MODERNIZATION AT CURRAN MIDDLE SCHOOL FOR:

BAKERSFIELD CITY SCHOOL DISTRICT

SHEET TITLE
SECTIONS BUILDINGS A,C,E,F&H & ENLARGED PLANS R.R.S BUILD C & F

SHEET IDENTIFICATION NUMBER
A-301

E4 SECTION MECHANICAL ROOM BUILDING E

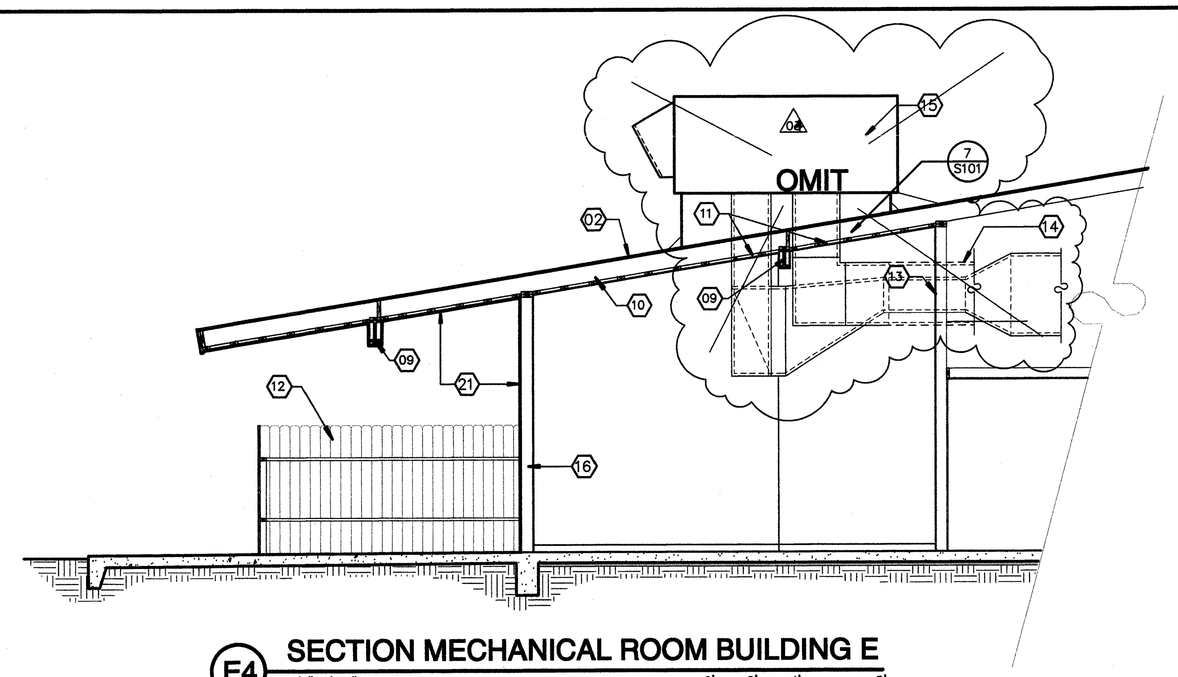
Item No. 22: Refer to Sheet A-301
Add #4
Section "E4" Omit HVAC installation and duct work. "A1 Partial Floor Plan" Revise to read. "Partial Floor Plan Building "C". Add door indicator 14.C to Girl's Restroom and 15.C to Boy's Restroom. "A3 Partial Floor Plan" Revise to read. "Partial Floor Plan Building "F". Add door indicator 13.F to Boy's Restroom and 14.F to Girl's Restroom. Interior Elevation "A5" add hand dryer on Elevation "B" center of wall at +40" A.F.F. to center of controls, coordinate with electrical drawings typical. Delete Keynote #11, #13, #15, & #25. Revise Keynote #23 to read. "See detail 17-S100 and 14B S-101 for wall condition requirements." Revise Keynote #26 to read. "Xlerator hand dryer XL-W with ADA Compliant recess kit see elevations for mounting requirements and electrical for electrical requirements." Delete Keynote #27. Revise Keynote #28 to read. "Soap dispensers see elevations for further requirements." Add Keynote #30 "See detail B5/A-501 for all mounting heights." Add Keynote #31 "New ceramic tile color per architect." Add Keynote #32 "Sanitary cove base."

A1 PARTIAL FLOOR PLAN BUILDING 'C'

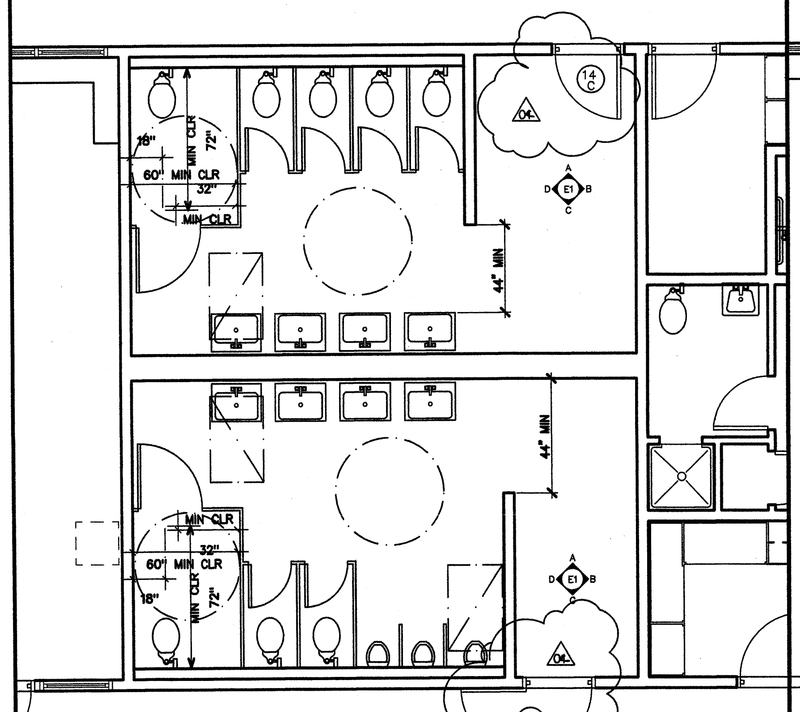
Item No. 7: Refer to Sheet A-301, Addendum drawing ADD-008 and Addendum drawing ADD-008.3, floor plans. Section reference 14B/S-101 and 17/S-100 were given per addendum 005. Replace this section reference with addendum drawing ADD-017. Replace addendum drawing ADD-008.1 with Addendum drawing ADD-023. Replace Addendum Drawing ADD-008.4 with Addendum Drawing ADD-023.1
Add #7

2. Sheet A-301 Replace "Partial Floor Plan Building "C" with Addendum Drawing ADD-008. Replace "Partial Floor Plan Building "F" with Addendum Drawing ADD-008.3 Replace"Interior Elevations Boys Girls Building "C", "F" similar with Addendum Drawings ADD-008.1 & ADD-008.4.
Add #5
